Olin Corporation

March 06, 2020

**RE: Response to USEPA Comments and Conditional Approval
Comprehensive Data Gaps Work Plan – Phase I
Olin Chemical Superfund Site (OCSS; “Site”) – Wilmington, MA**

Figure
3

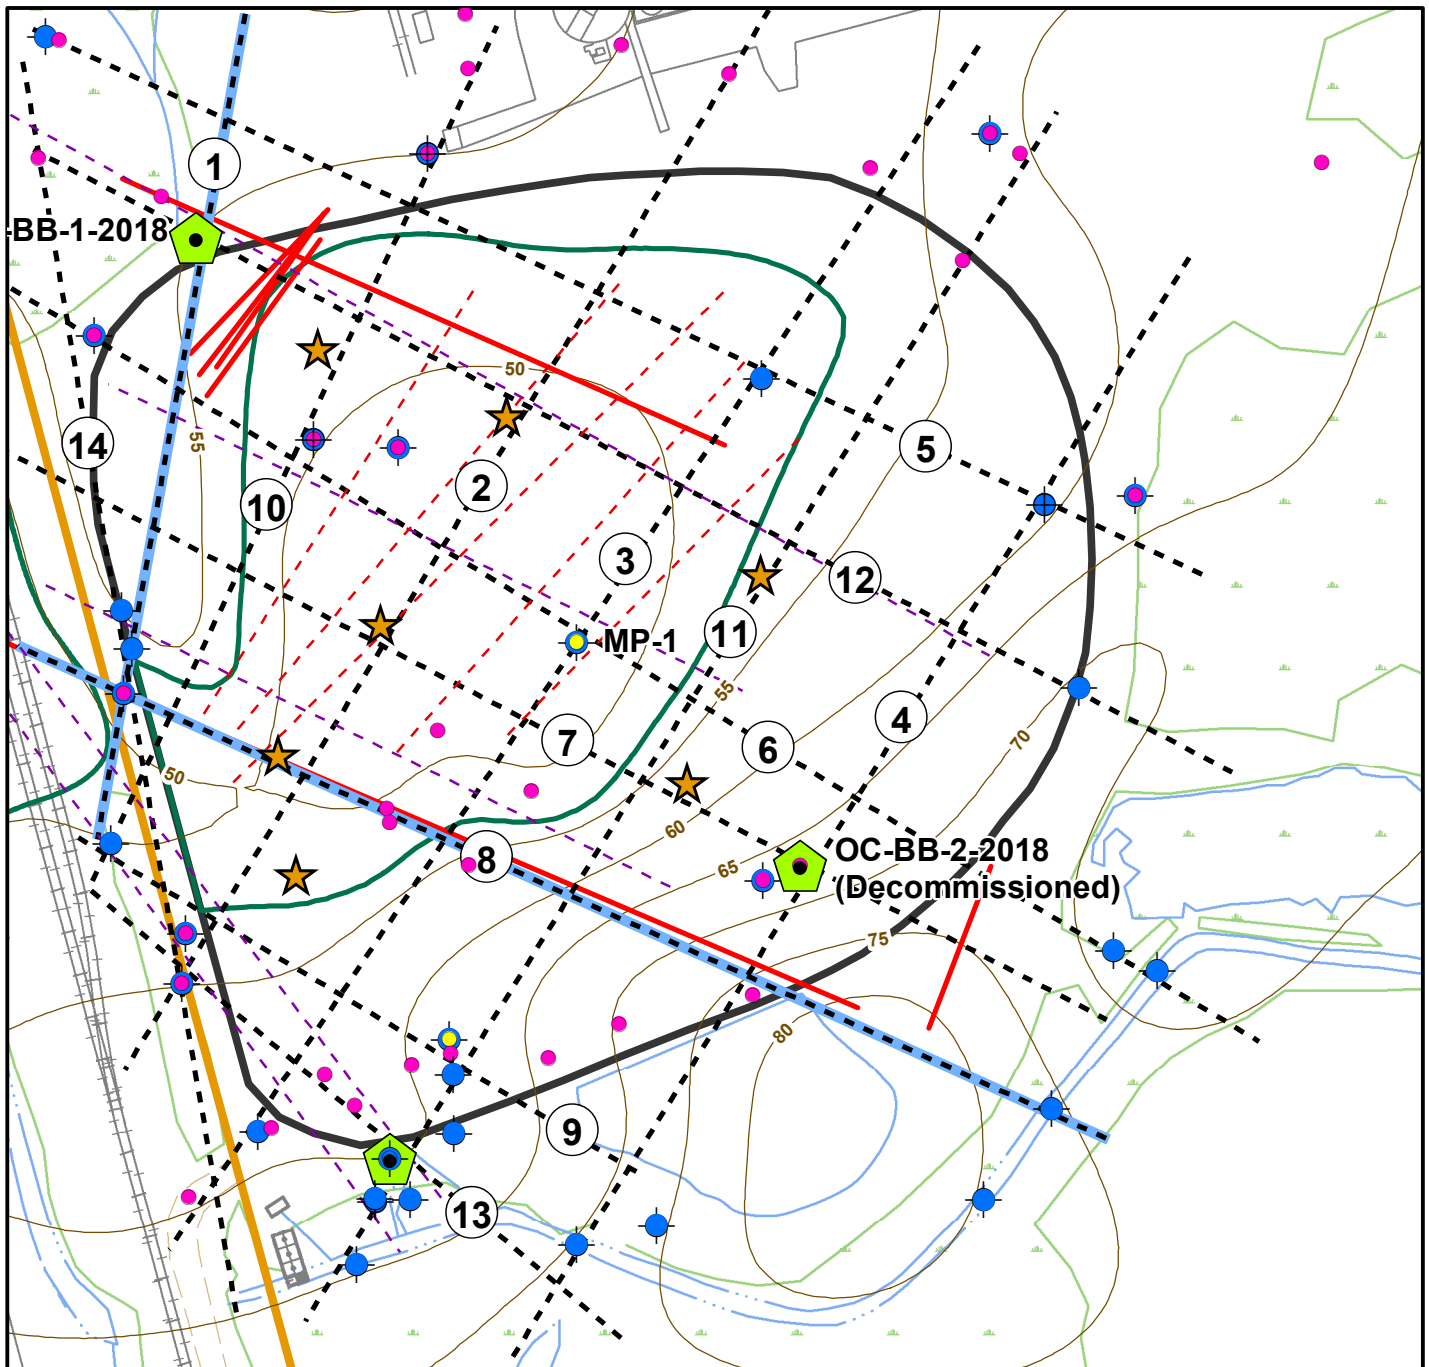
- Seismic line locations have been updated as recommended by USEPA and each target area seismic survey will be supplemented with 2 EM lines (Figures 3, 4, 5, 7, and 8);
- The low-frequency GPR work recommended in the Jewel Drive area (Figure 4) will be implemented concurrently with the seismic survey work.
